CITY OF MADISON
CITY ENGINEERING DIVISION
DEPARTMENT OF PUBLIC WORKS
PLAN OF PROPOSED IMPROVEMENT

N FRANKLIN AVENUE & LYNN TERRACE -
ASSESSMENT DISTRICT 2025
CITY PROJECT NO. 15113
CONTRACT NO. 8766

ADDENDUM 1 - 02/11/25
UPDATED SHEETS: D5-D10,
PD1-PD5, P1-P6, X1-X13

REVISION 1 - 04/03/25
UPDATED SHEETS: COVER,
D6, PD1-PD3, P1-P3, U1-U9,
W1-W9, X3-X11
SHEET ADDED: U10

15113
PD-2

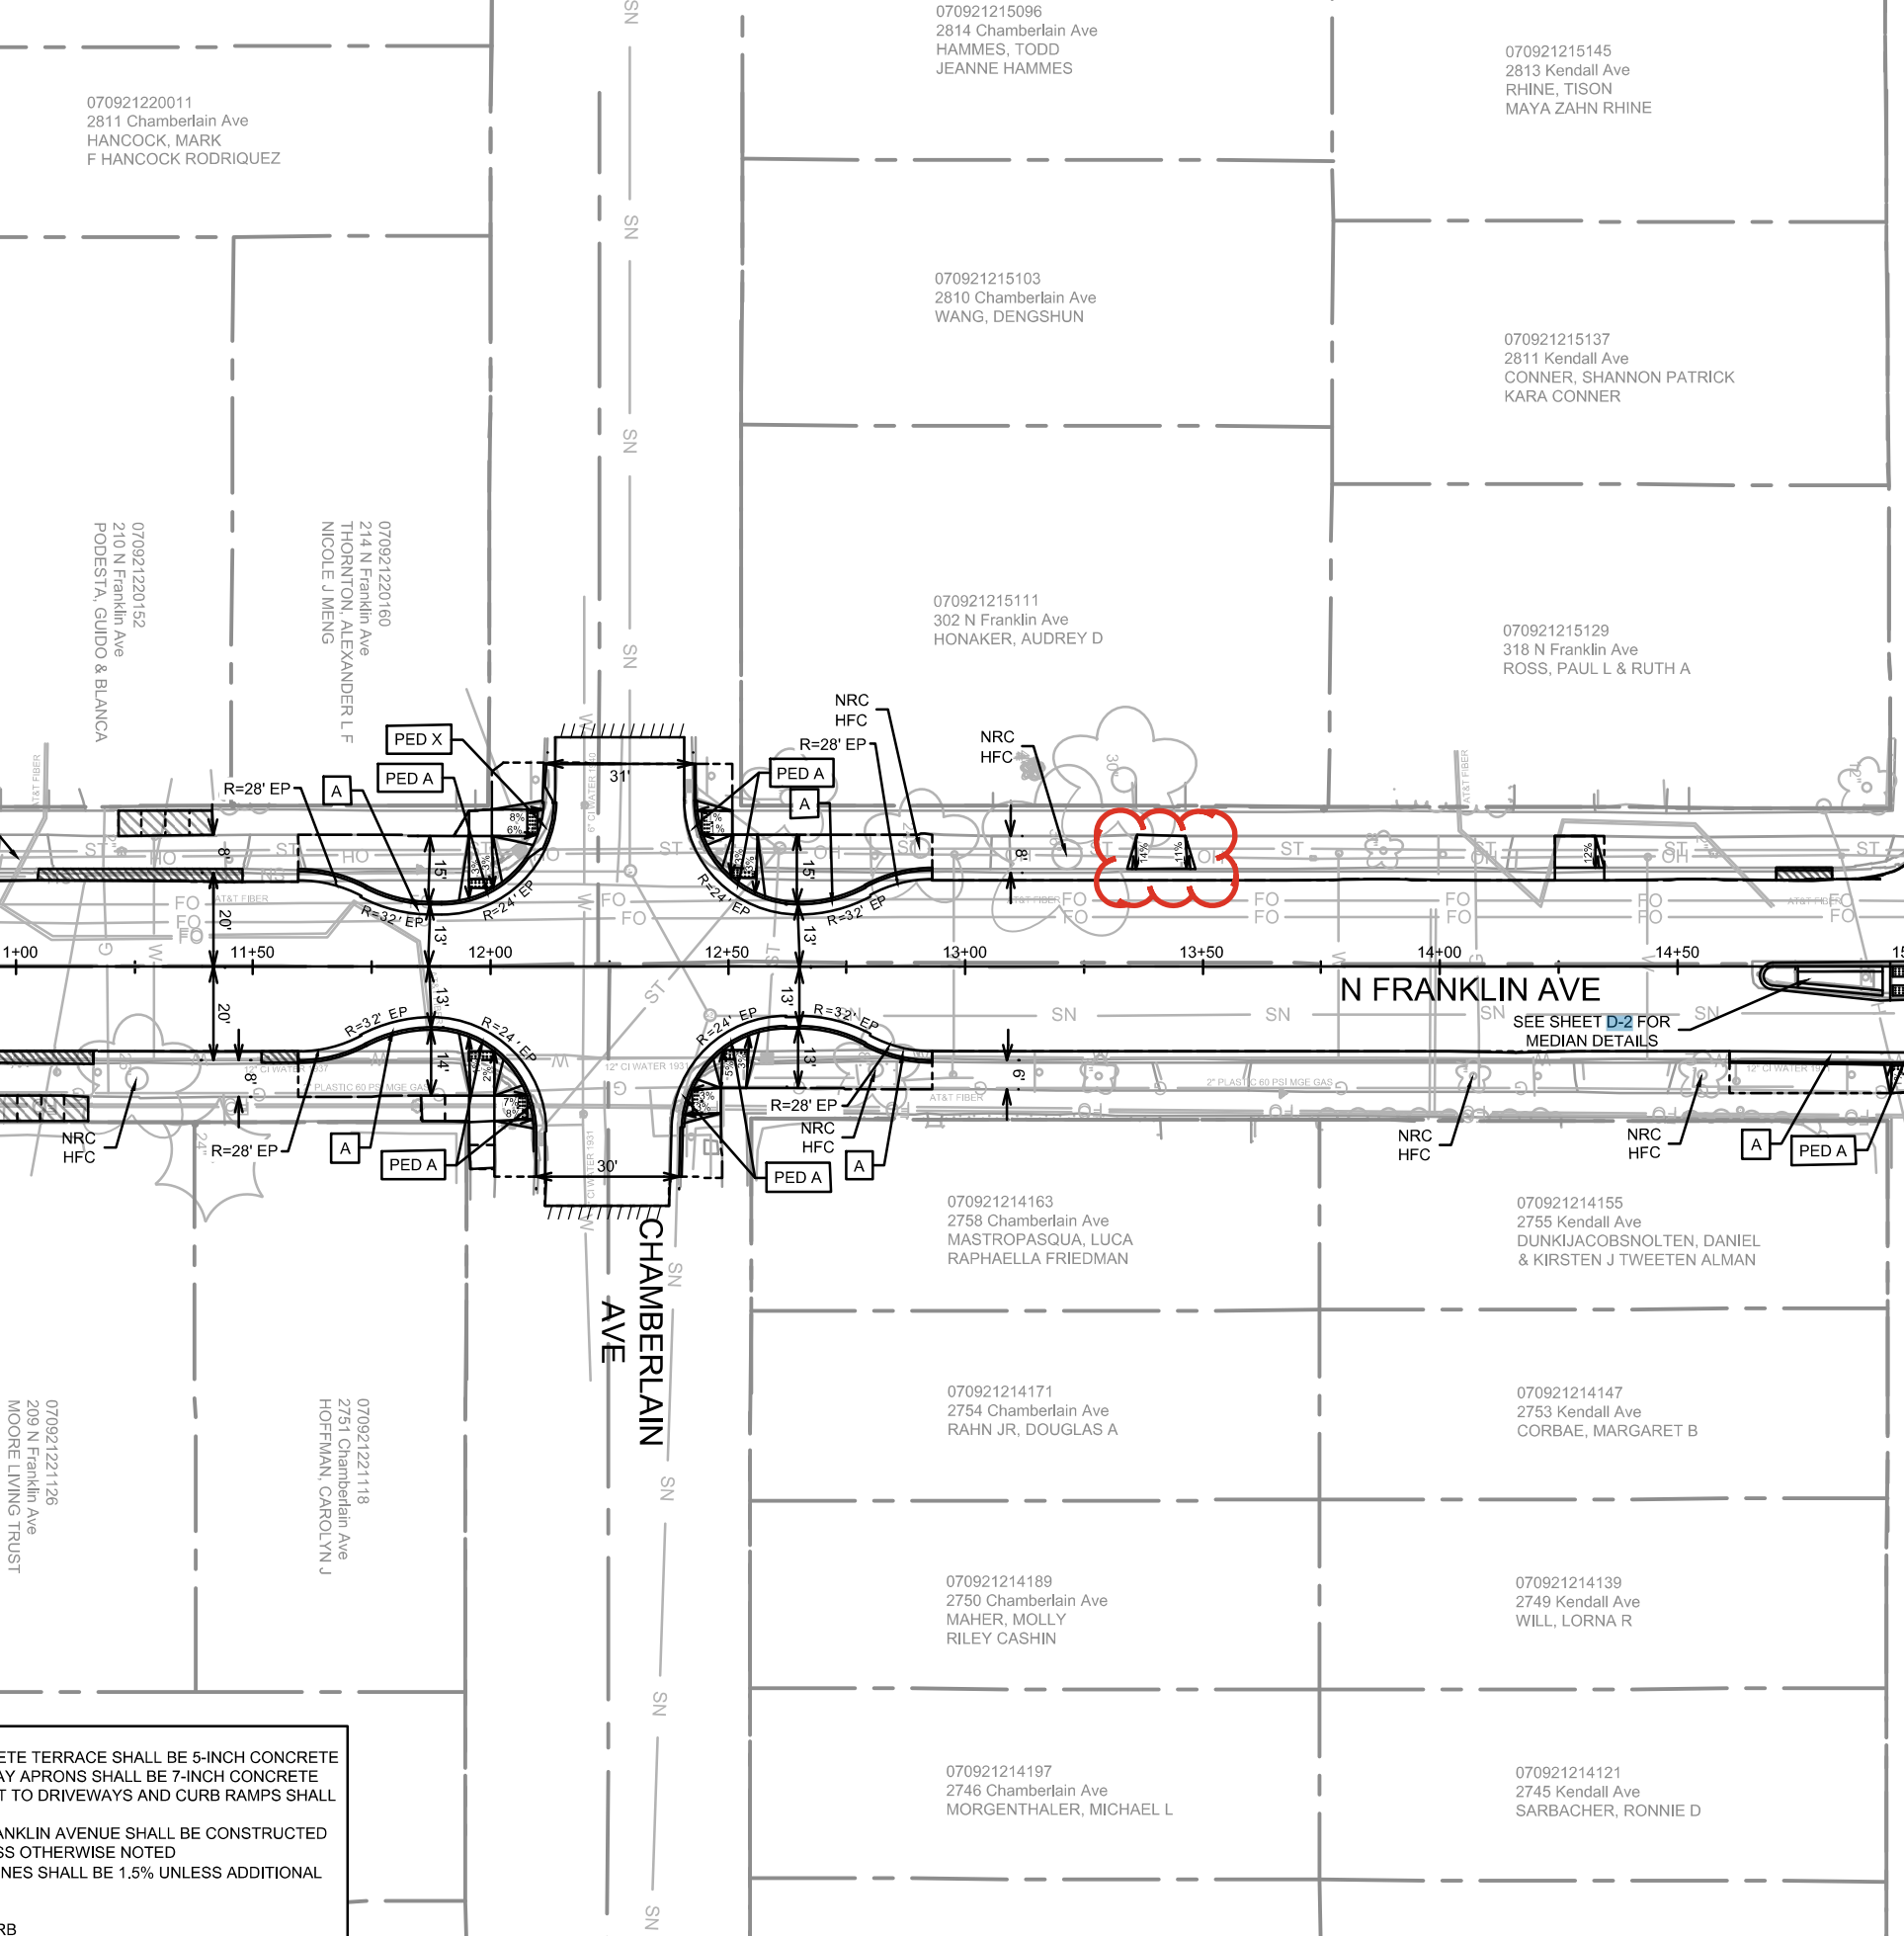
ADDENDUM 1 - GCIT - 02/11/2025
- REVISED TERRACE EXCAVATION SITES

REVISION 1 - GCIT - 04/03/2025
- UPDATED CURB REPLACEMENT LIMITS
- ADDITIONAL DRIVEWAY APRON

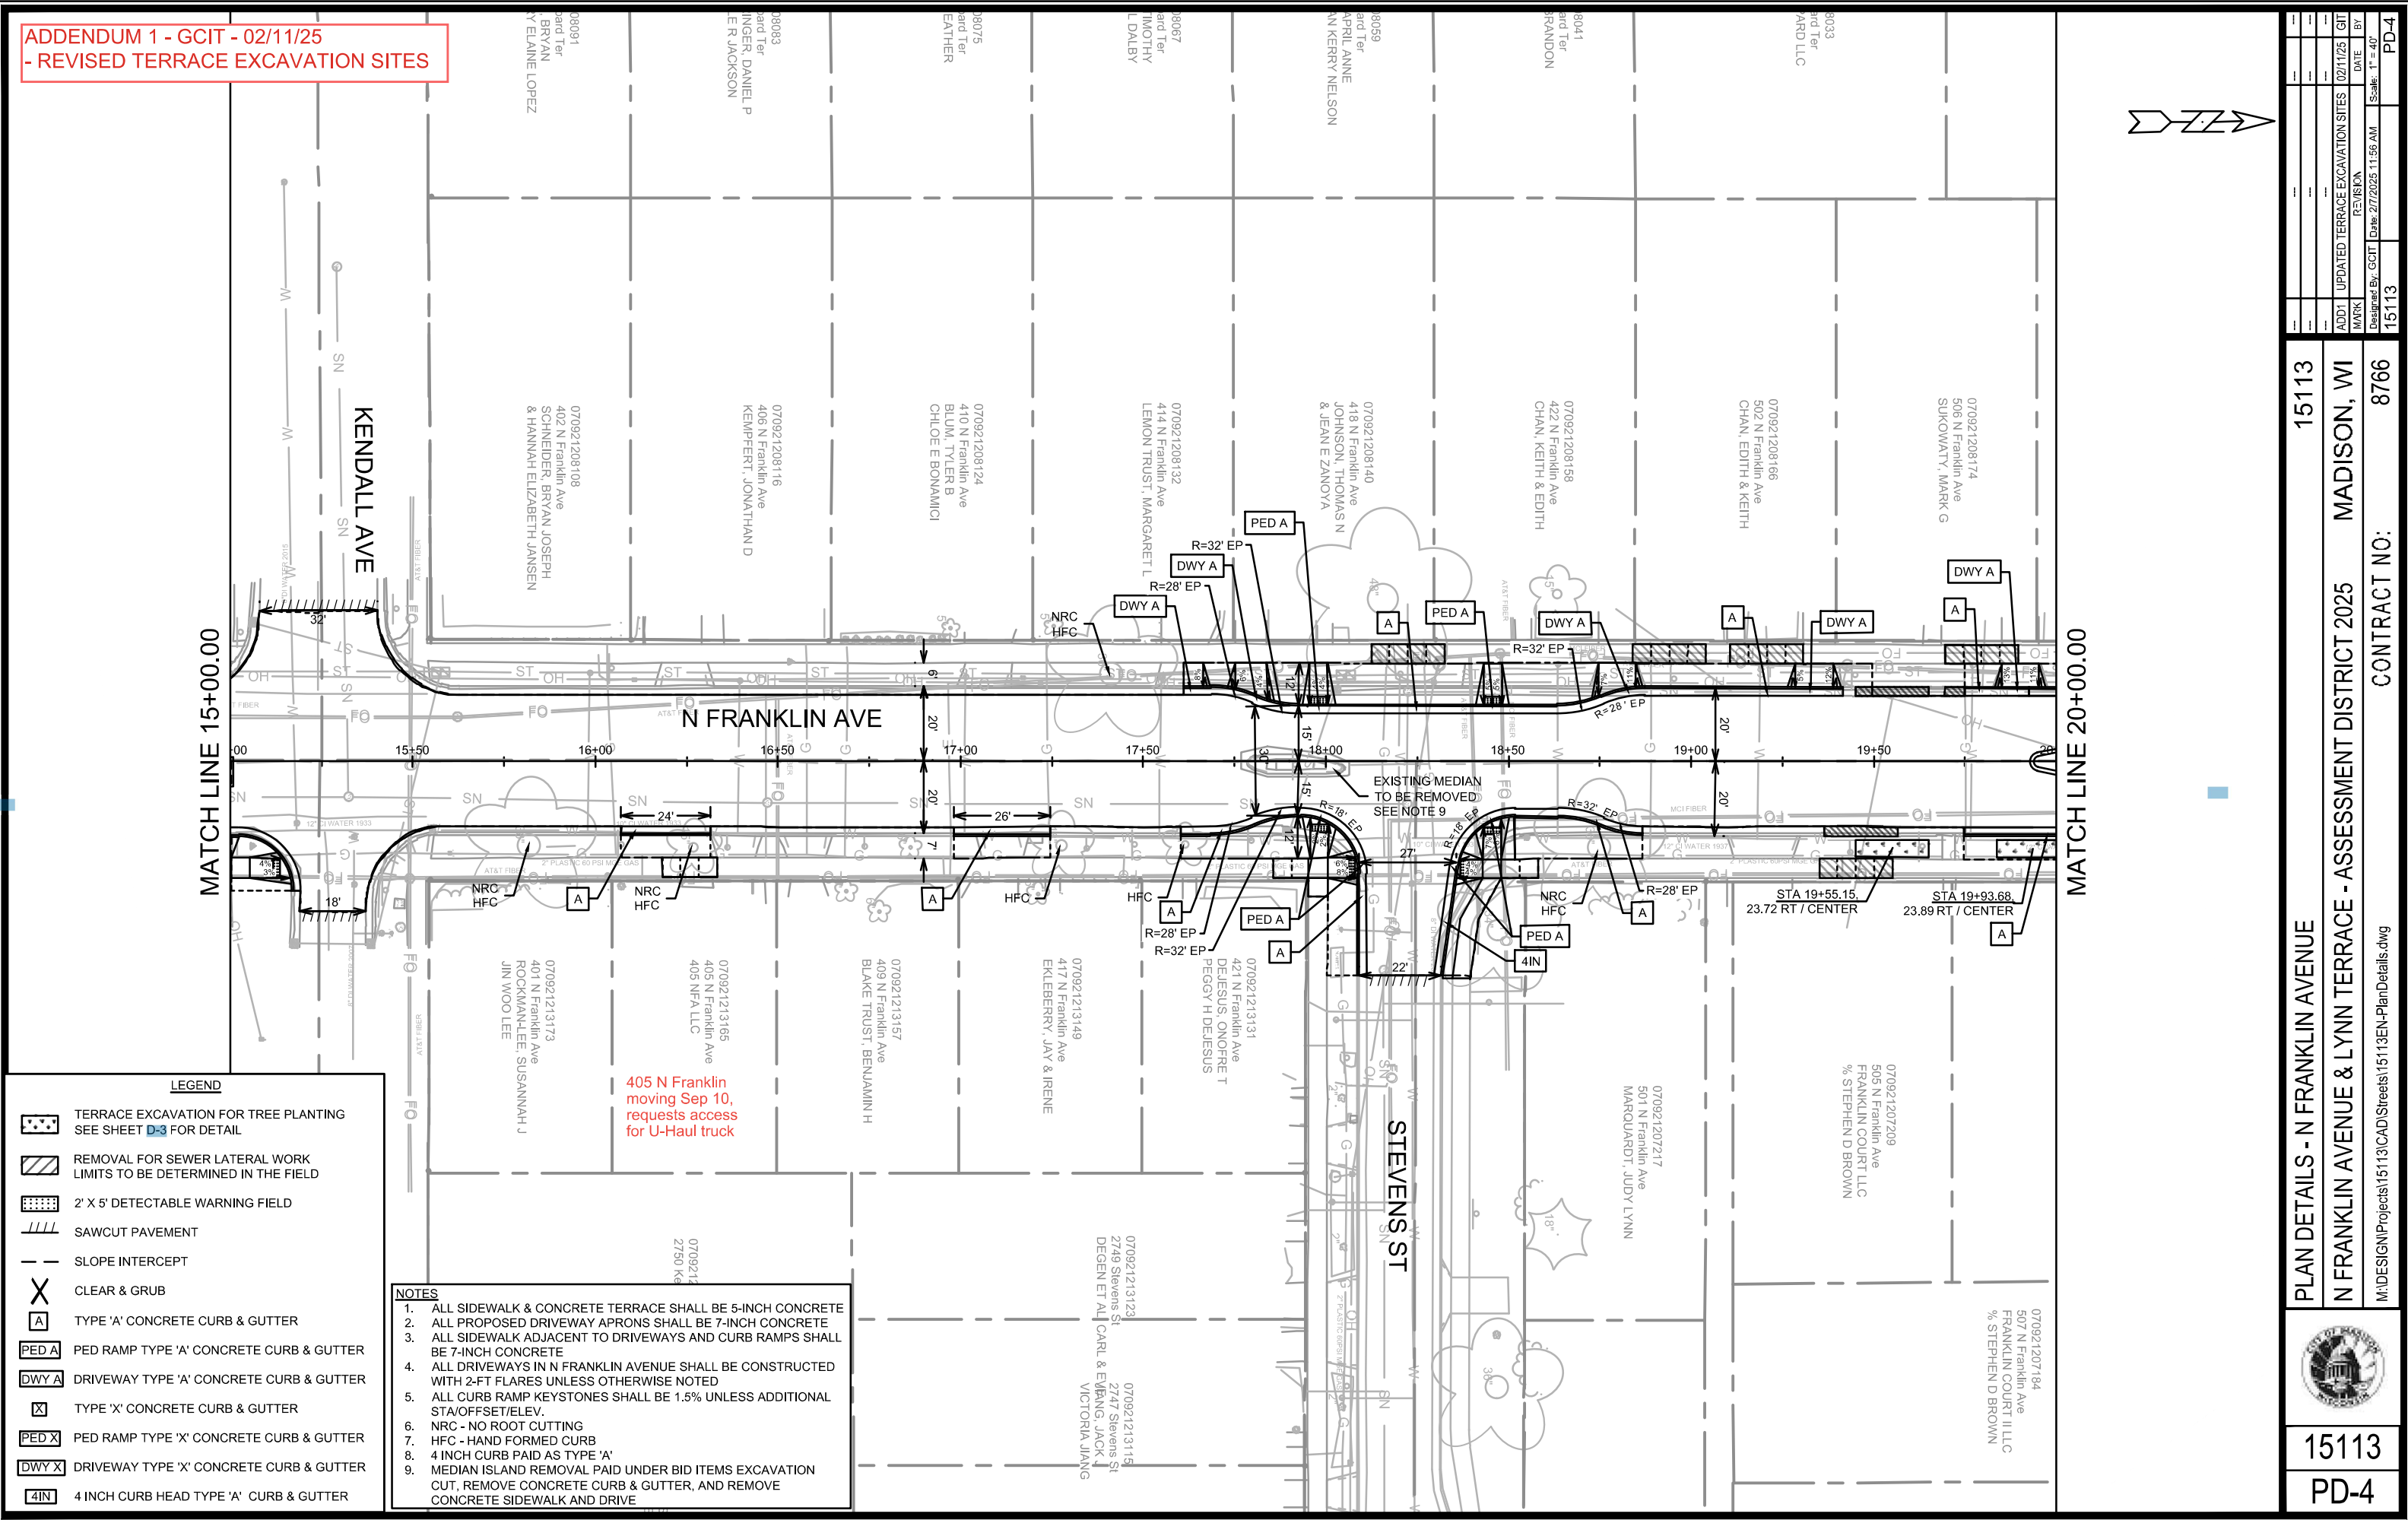
ADDENDUM 1 - GCIT - 02/11/25
- REVISED TERRACE EXCAVATION SITES

15113		15113													
PD-5		PLAN DETAILS - N FRANKLIN AVENUE		15113													
		N FRANKLIN AVENUE & LYNN TERRACE - ASSESSMENT DISTRICT 2025		MADISON, WI													
		M:\DESIGN\Projects\15113\CAD\Streets\15113EN-PlanDetails.dwg															
		CONTRACT NO:		8766

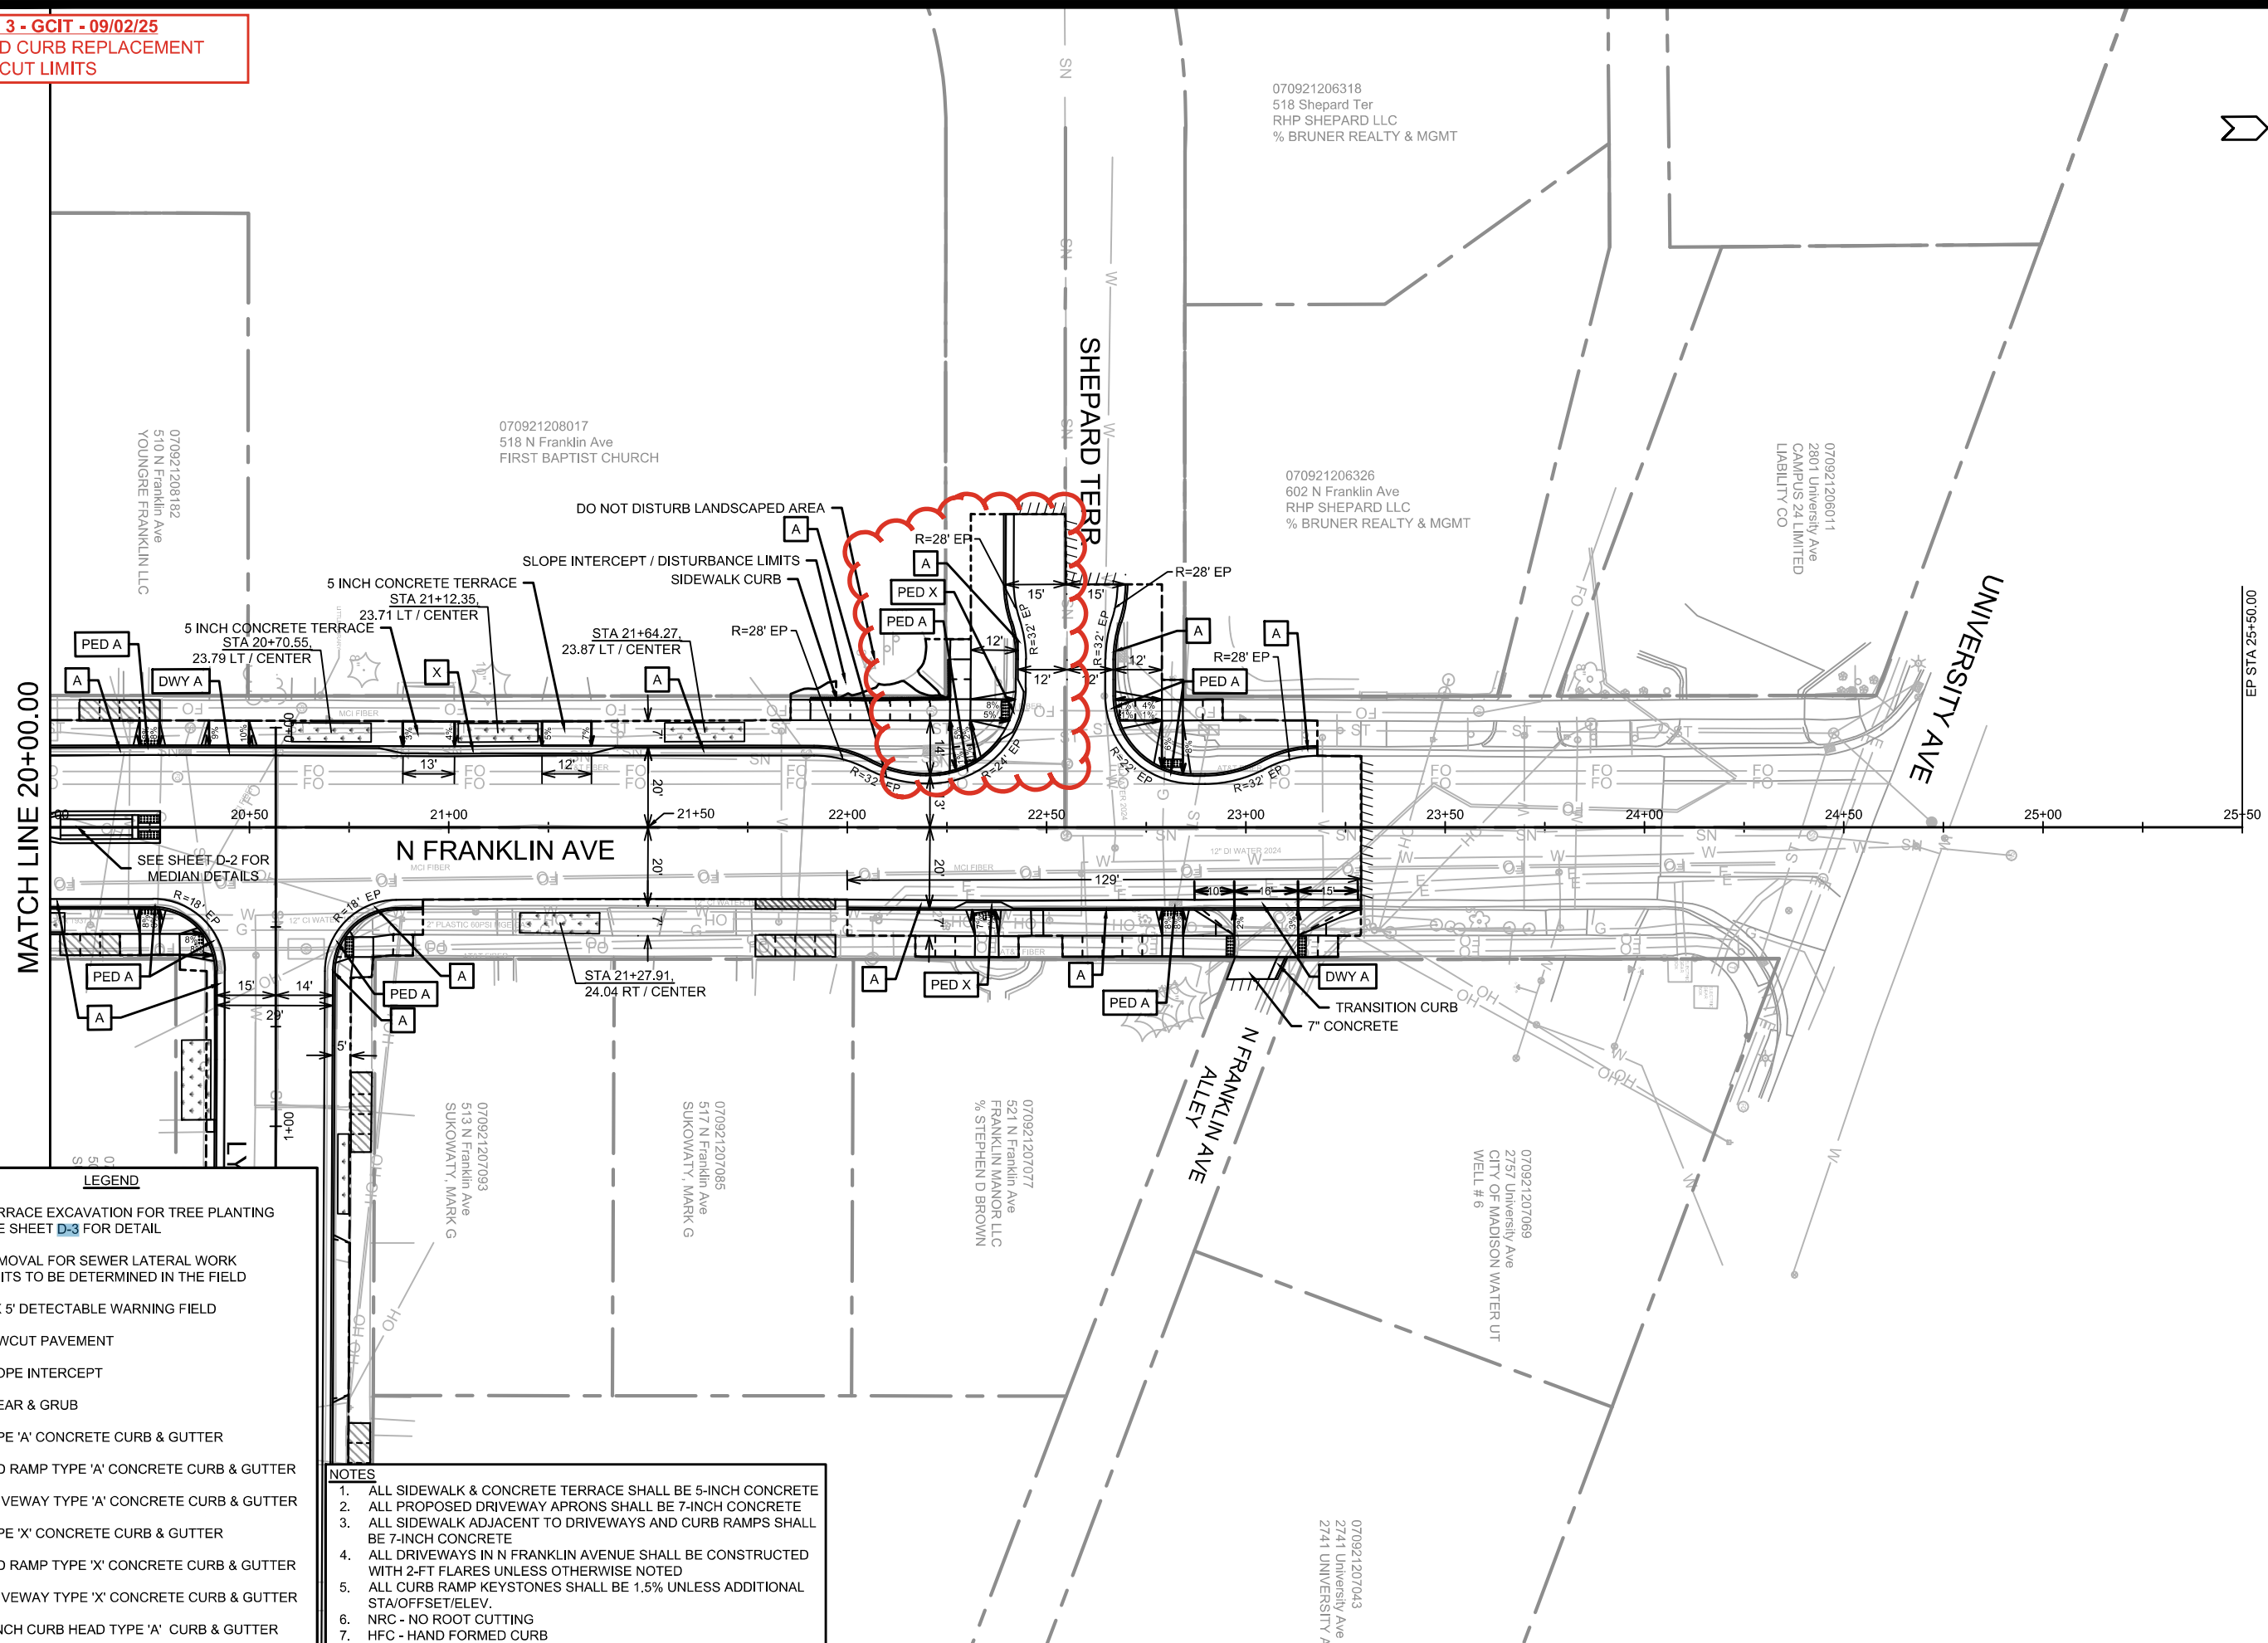
REVISION 3 - GCIT - 09/02/25
- UPDATED CURB REPLACEMENT
AND SAWCUT LIMITS
